BURLINGTON DEVELOPMENT REVIEW BOARD

Tuesday, October 20, 2020, 5:00 PM

Agenda

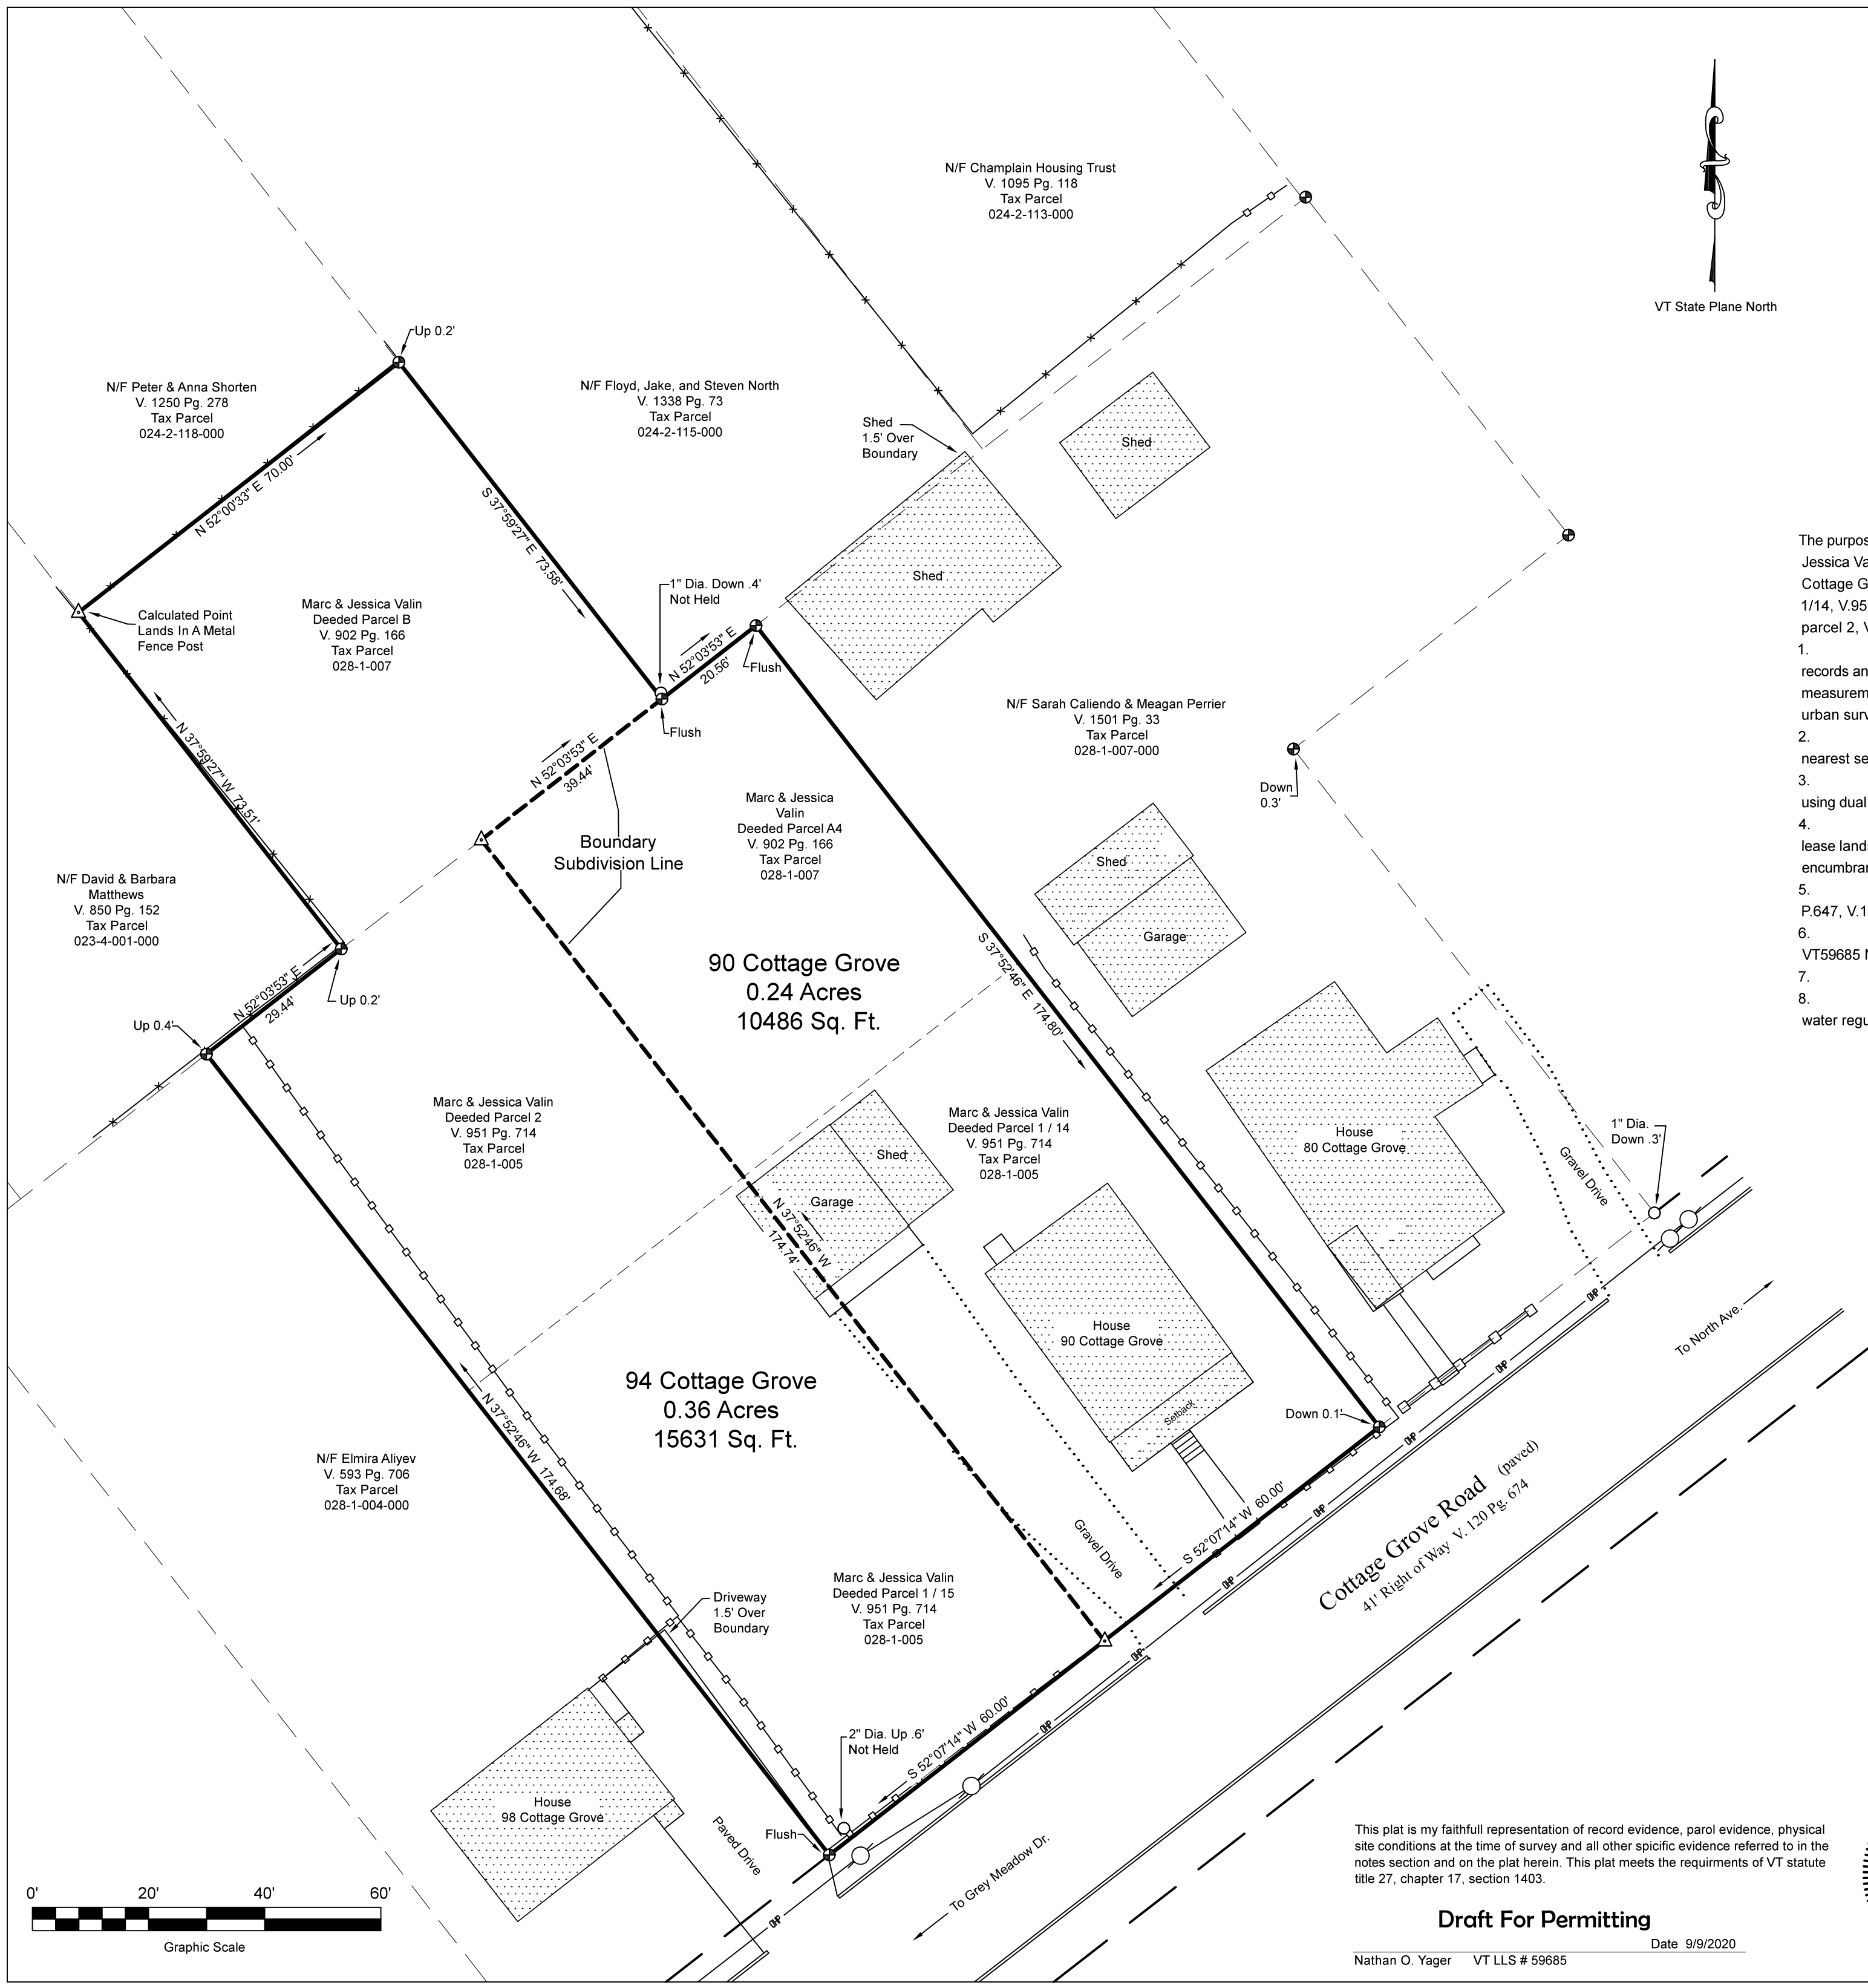
2. **Prior to filing the mylar** in the city land records, the subdivision plat shall be revised to reflect the following:
 - a. Deletion of the detached garage/shed from the subdivision plat;

- b. Sheet size of 24" x 36" with one-inch margins on three sides and a two-inch margin on the side to be bound;
 - c. A scale of 1" = 40;' and,
 - d. Obtain signatures for all certifications and endorsements required under Sec. 10.1.11 (a) of the Comprehensive Development Ordinance. These signature blocks shall be included on the final subdivision plat.
